## Drainage Letter

## Viewpoint Estates

Filing No. 2

Update PCD File # to  
SF-21-042

MVE PROJECT 61099  
MVE DRAWING EX-DRN

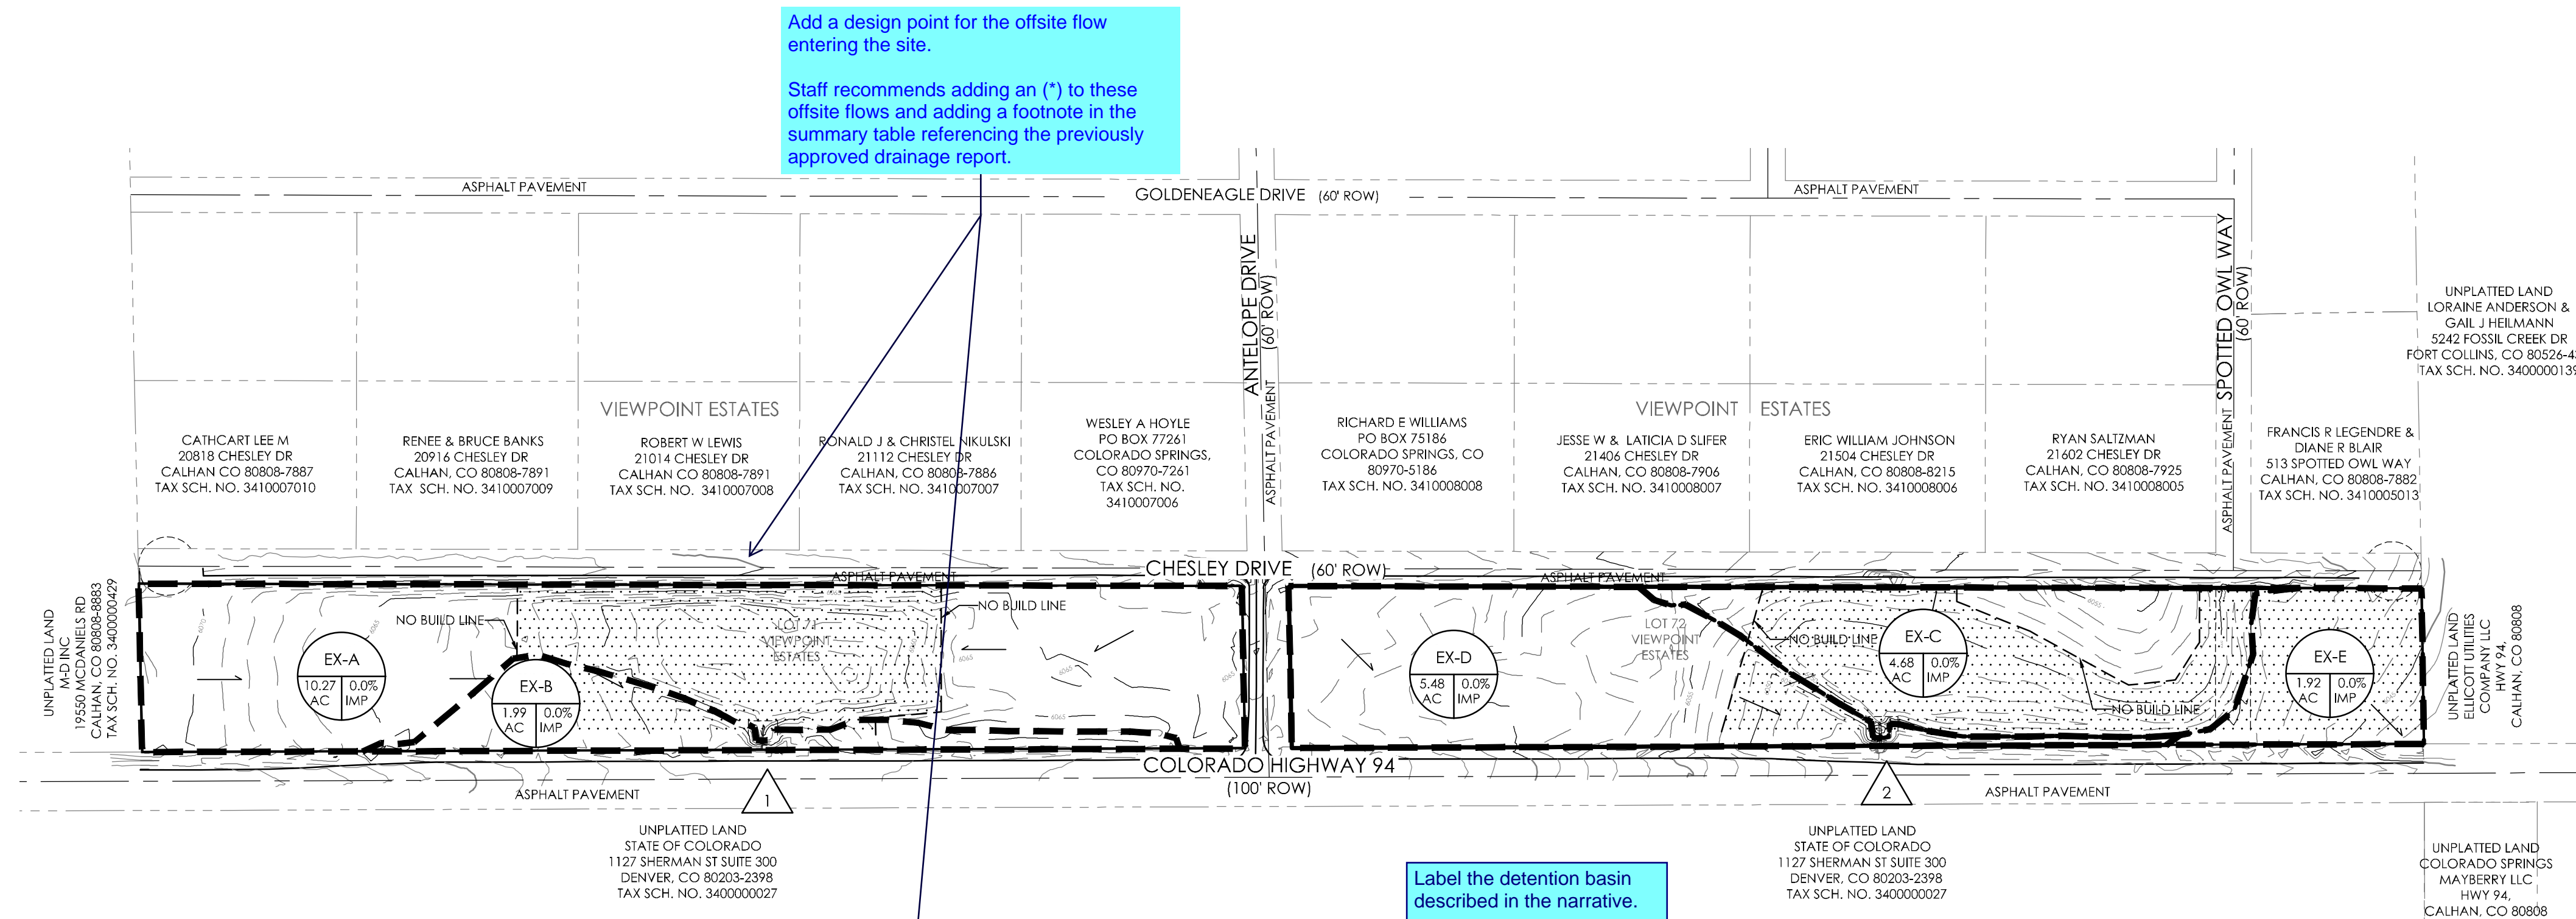
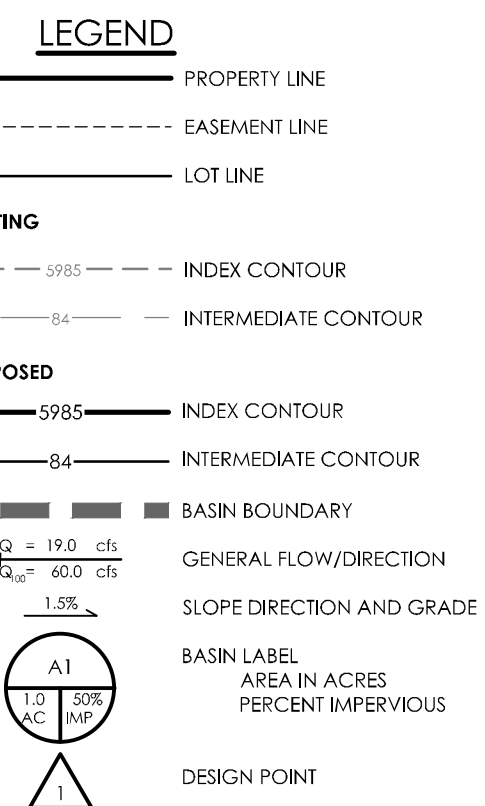
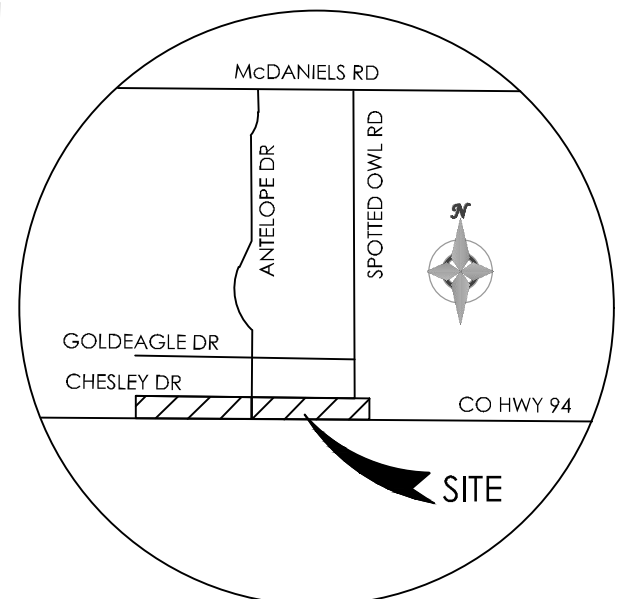
Add a design point for the offsite flow entering the site.

Staff recommends adding an (\*) to these offsite flows and adding a footnote in the summary table referencing the previously approved drainage report.

Show and label all the existing culverts in both the existing and proposed drainage maps.

Label the detention basin described in the narrative.

Update the narrative to identify who will be maintaining the detention basins.
